# Cambourne to Cambridge: In-Highway Proposals for High Quality Public Transport Scheme

*Produced for Cambridge Past, Present & Future  
by Edward Leigh MA MSc, February 2021*

Figure 10: Changes proposed to A1303 at M11 junction as part of Bourn Airfield planning application (S/3440/18/OL)

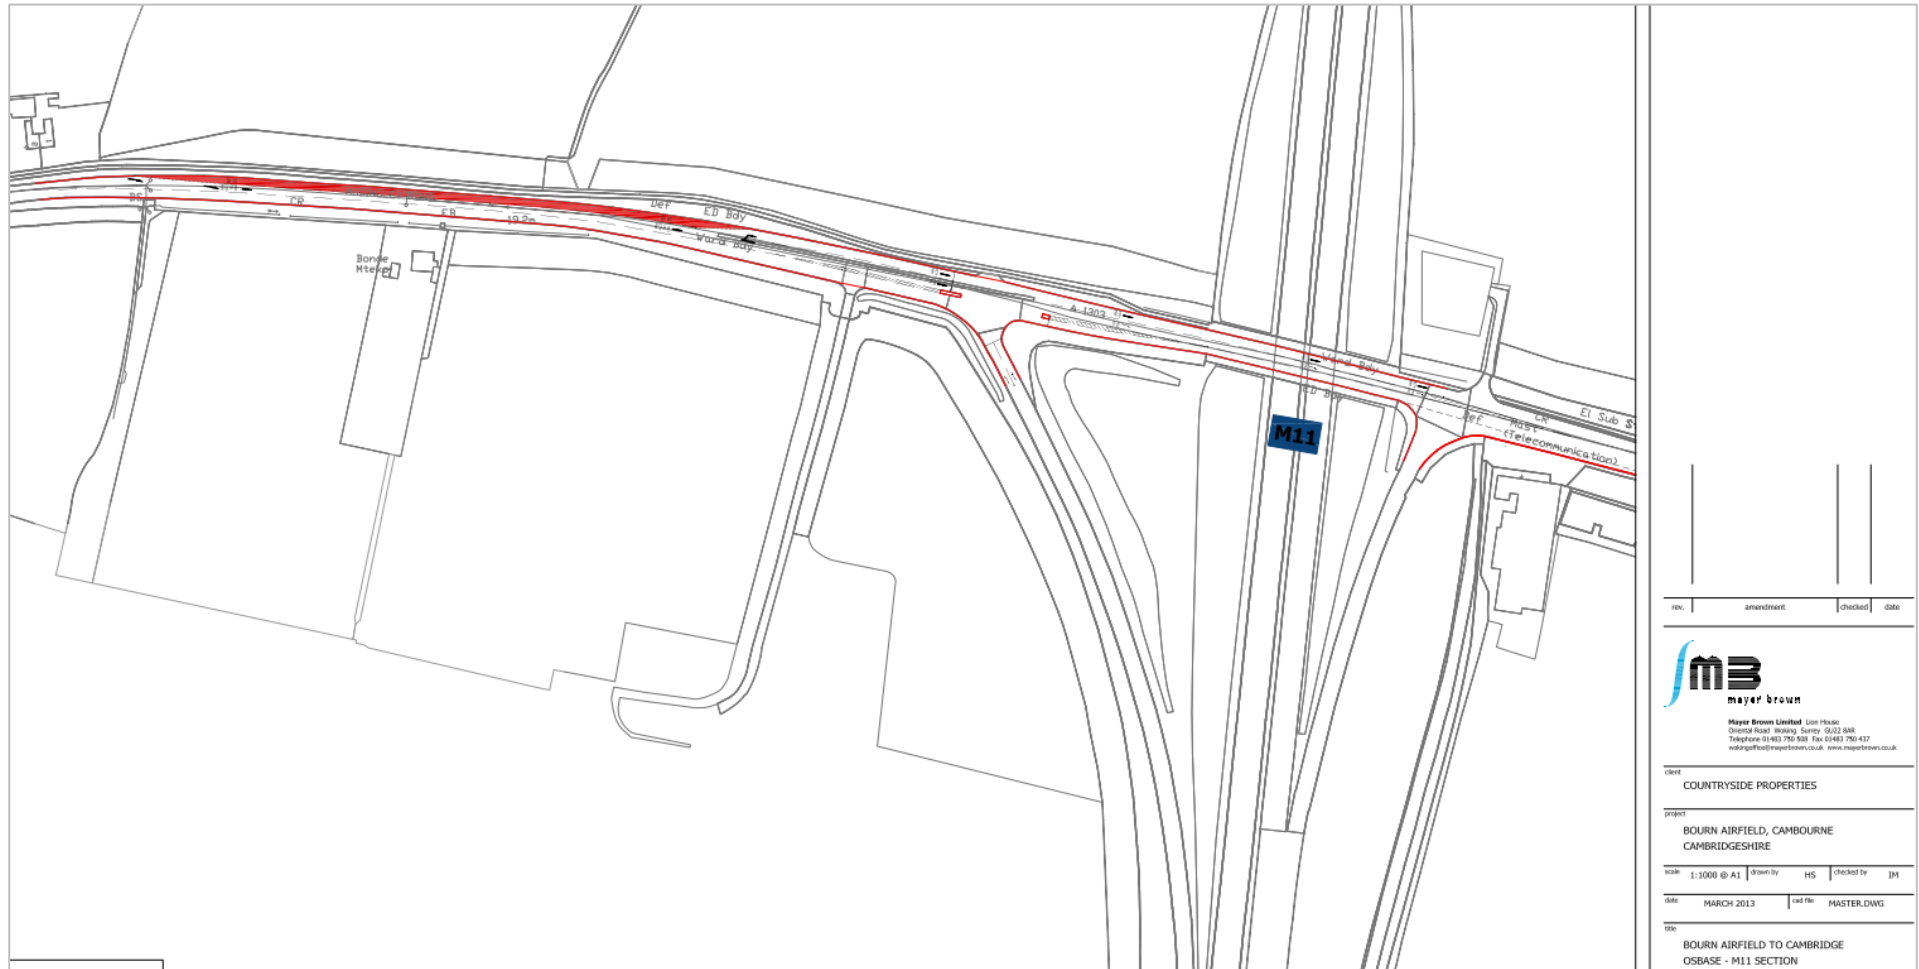
Note that the planning application for Bourn Airfield (S/3440/18/OL) includes a similar proposal to segregate M11-bound traffic from city-bound traffic (see Figure 10). Both options should be modelled with accurate peak-time traffic volumes to determine which benefits buses more.

Figure 13: Westbound bus lane into Madingley Mulch roundabout (from QW 3.1/Mott MacDonald)

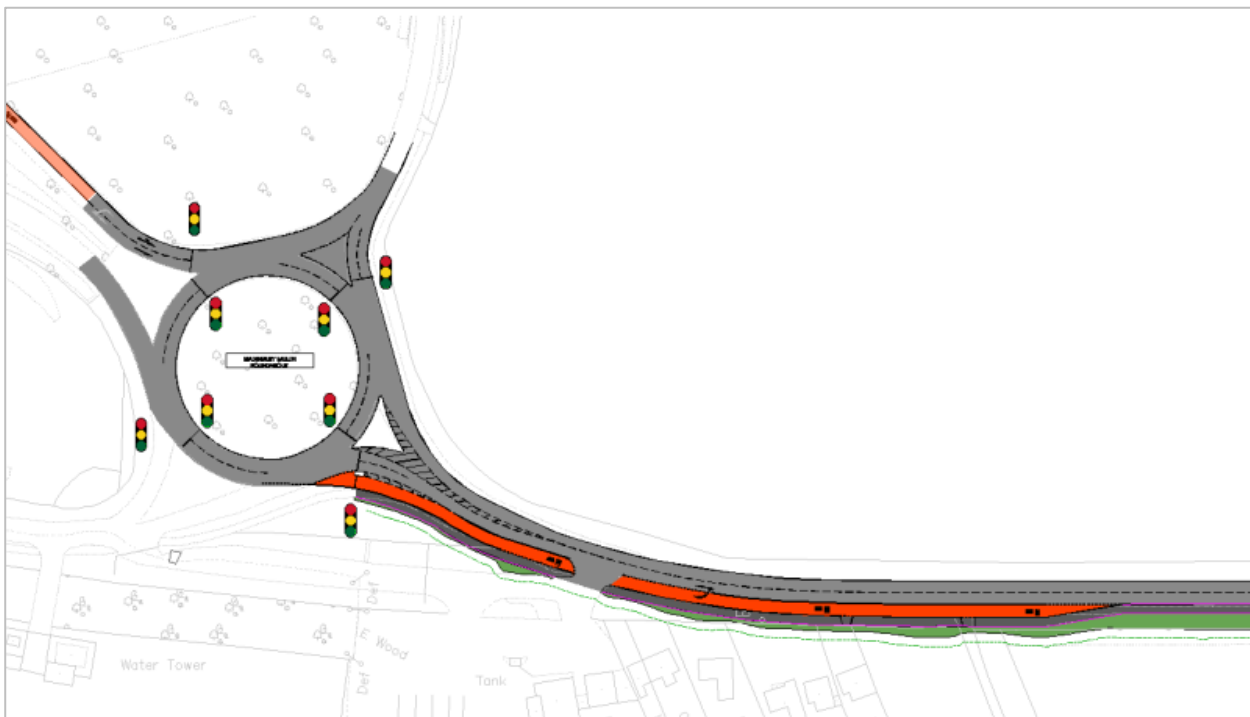
**3e. Outbound bus lane:** A westbound nearside bus lane could be accommodated within highway land to the south of Madingley Mulch roundabout (see Figure 12). This would provide buses with a congestion-free route if and when a queue builds on the approach to the roundabout (see Figure 13). (Reviewed in QW3.1.)

Figure 14: Four-lane configuration of M11 “Rectory Farm” bridge (from RFB page 33 © 2016 Atkins Ltd)

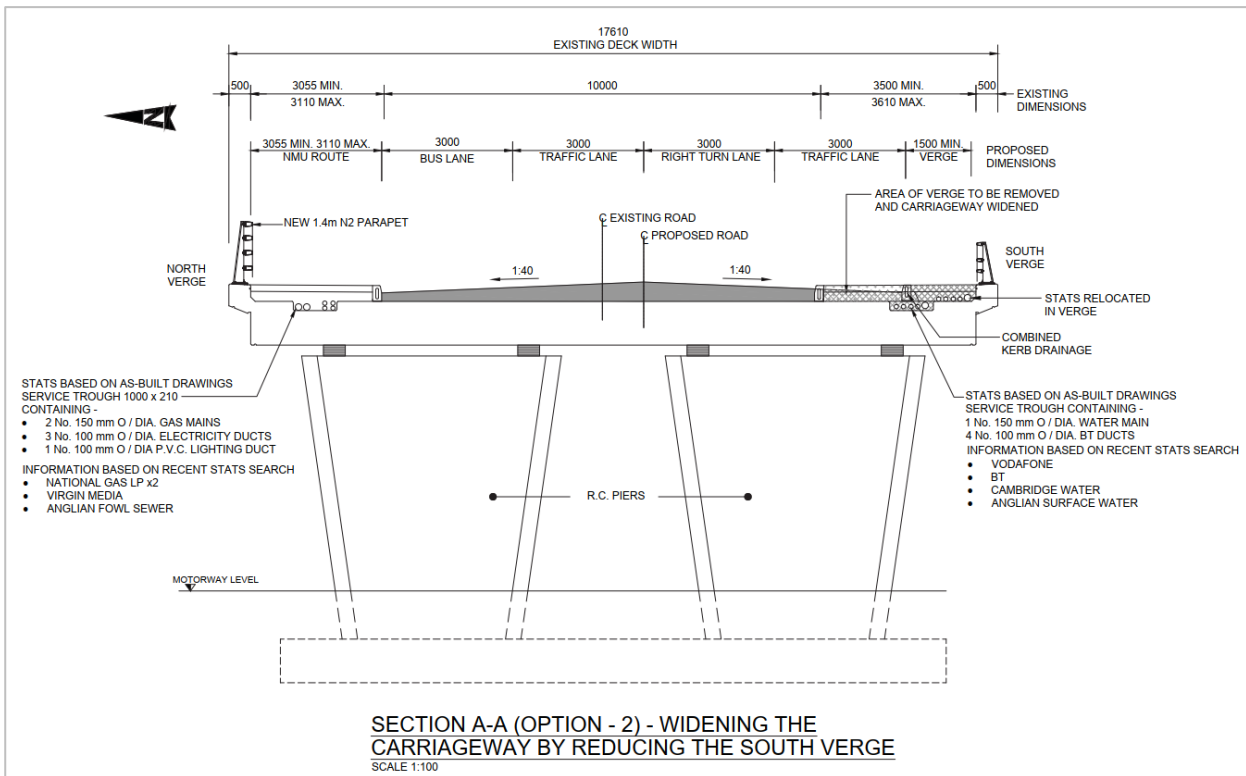
**3c. Bus lane (not recommended):** Although RFB details in Option 2 (see Figure 14) how the bridge can accommodate four 3m-wide traffic lanes in addition to the existing NMU lane, the gain is relatively small once the filter lane is extended beyond behind the end of the existing bus lane (1a).

Figure 20: Reassignment of hatched outside lane on A428 at the Girton Interchange to create a 640m long bus and coach lane

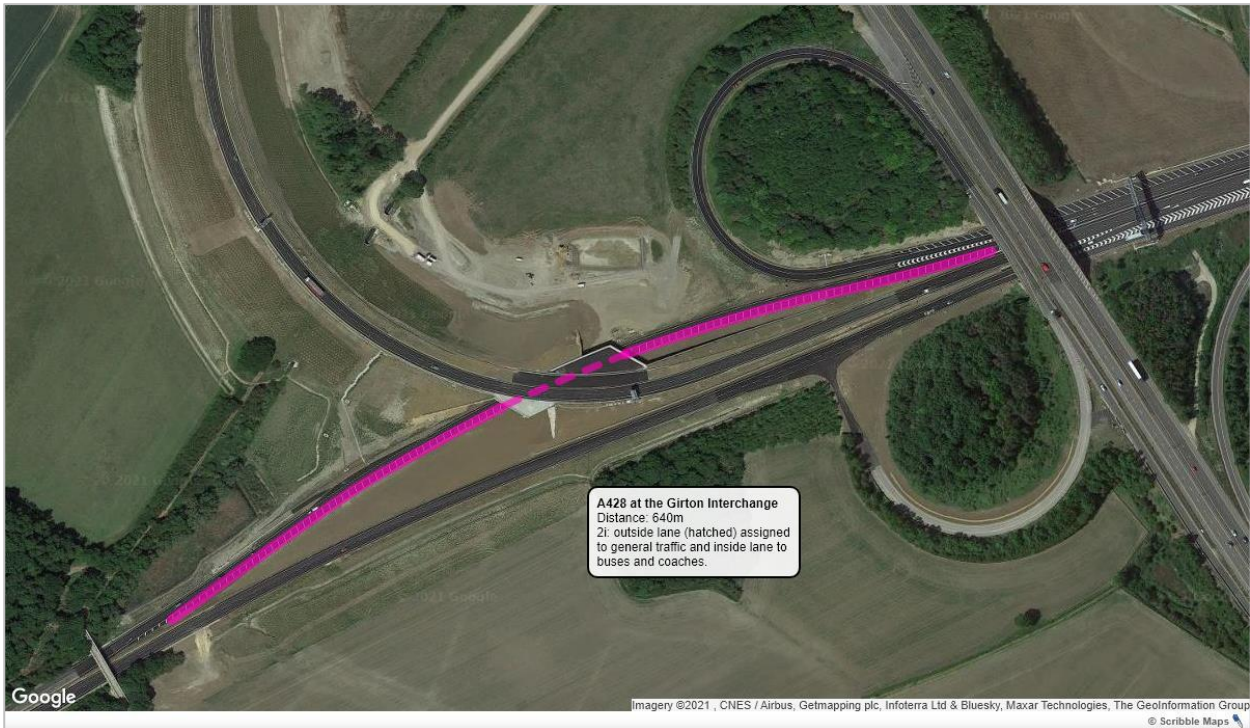
**2j. Reassign hatched carriageway on A428:** Moving the general traffic lane into the offside hatched area would free up the inside lane to be used by buses and coaches (and emergency vehicles). If the lanes merge before the M11 overbridge, this would provide a 640m bus lane to bypass congestion (see Figure 20).
